Subject: **COLUMBIA GENERATING STATION, DOCKET NO. 50-397
RESPONSE TO REQUEST FOR ADDITIONAL INFORMATION
RELATED TO EXIGENT LICENSE AMENDMENT REQUEST FOR
CHANGE TO TECHNICAL SPECIFICATION 3.8.7 DISTRIBUTION
SYSTEMS – OPERATING**

RESPONSE TO REQUEST FOR ADDITIONAL INFORMATION

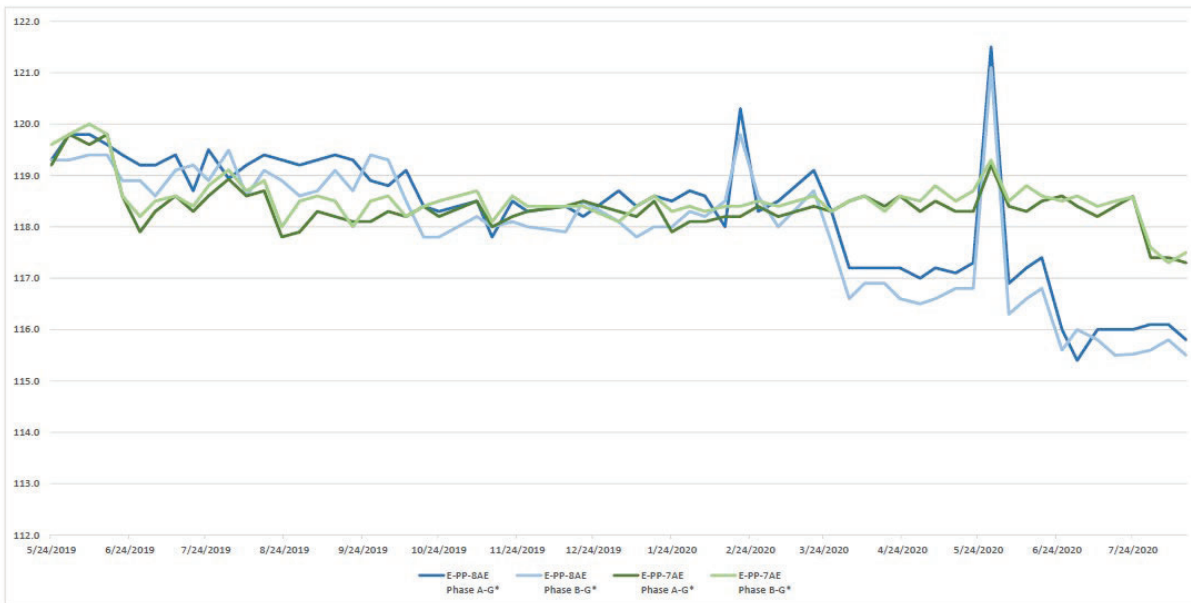
An August 15, 2019, LAR requested an extension to an allowable outage time (AOT) to replace failing transformer E-TR-7A/2 (feeds power panel E-PP-7AF) in Division 1. The August 20, 2020, LAR under review requests an extension to an AOT to replace E-TR-8A/1 (feeds power panel E-PP-8AE) in Division 2. The degradation and subsequent need to replace two transformers in this short time may indicate that there is a common degradation mechanism. If a common degradation mechanism is identified, any risk calculations from which risk insights used support changes to technical specifications are developed should include appropriate contributions from common cause failures (CCFs).

1. Please clarify if there is a potential common cause mechanism and identify the systems/sub-systems where the components that could be subjected to this mechanism are located.
2. Please summarize the impact this potential common cause mechanism has on the capability of the affected components to fail to successfully operate to prevent and/or mitigate transients.
3. Please evaluate and summarize the risk implications of this potential common cause mechanism causing the affected components to fail and the effects of those failures on risk associated with the requested extended AOT.

TS Bases 3.8.7 AC Distribution Systems Operating notes that OPERABLE AC electrical power distribution subsystems require the associated buses to be energized to their proper voltages. The figure below plots data obtained from weekly voltage surveillances under TS Surveillance Requirement 3.8.7.1 on E-PP-8AE and the Division 1 redundant power panel E-PP-7AE for the current operating cycle. While E-PP-8AE has shown gradual declining performance, the redundant subsystem E-PP-7AE has remained well above its administrative limit of 115 voltage alternating current (VAC). E-PP-7AE has experienced a recent step change in July 2020 however, the power panel output is stable above 117 VAC which is considered to be acceptable margin to the administrative limit of 115 VAC at this time.

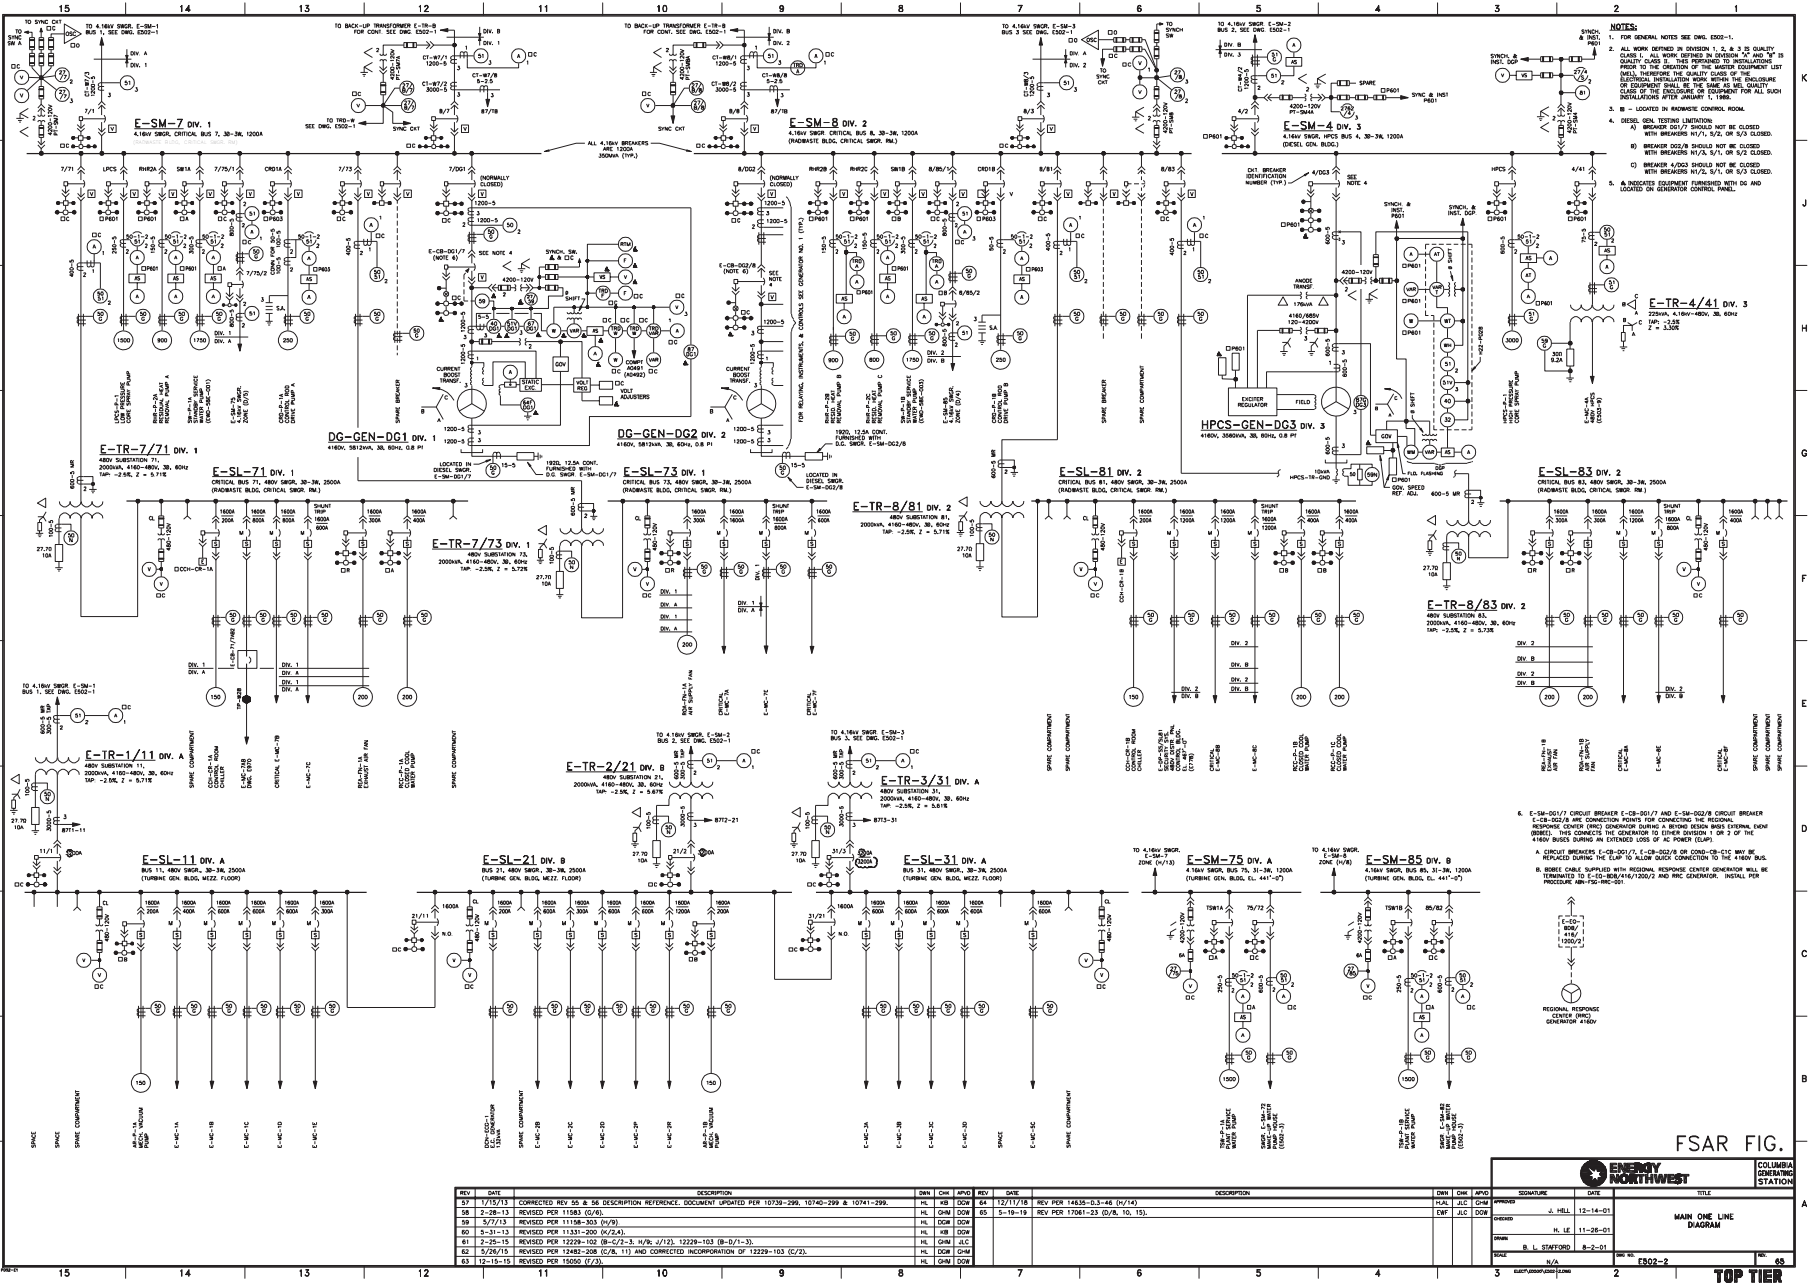
On Page 2 of Enclosure 1 of the LAR, the table for "AC Power Distribution Subsystems" shows the various safety-related buses and power panels for each division. For a better understanding of line-up of the distribution subsystems, please provide requisite single line drawing for each division showing the distribution transformer connections between various buses and panels listed in the table.

The list of requested drawings, which show the AC Power Distribution subsystems with transformer connections are provided below and are placed in Attachment 1 to this Enclosure.

1. E502-1 – Main One Line Diagram (depicts feeds to Divisions 1-3 4160 V switchgear)
2. E502-2 – Main One Line Diagram (depicts Divisions 1-3 4160 V switchgear, SM-7, SM-8, SM-4 feeding 480 V switchgear SL-71, SL-73, SL-81, SL-83 feeding 480V Motor Control Centers (MCCs) 7A, 7B, 7F, 8A, 8B, 8F and 4A)
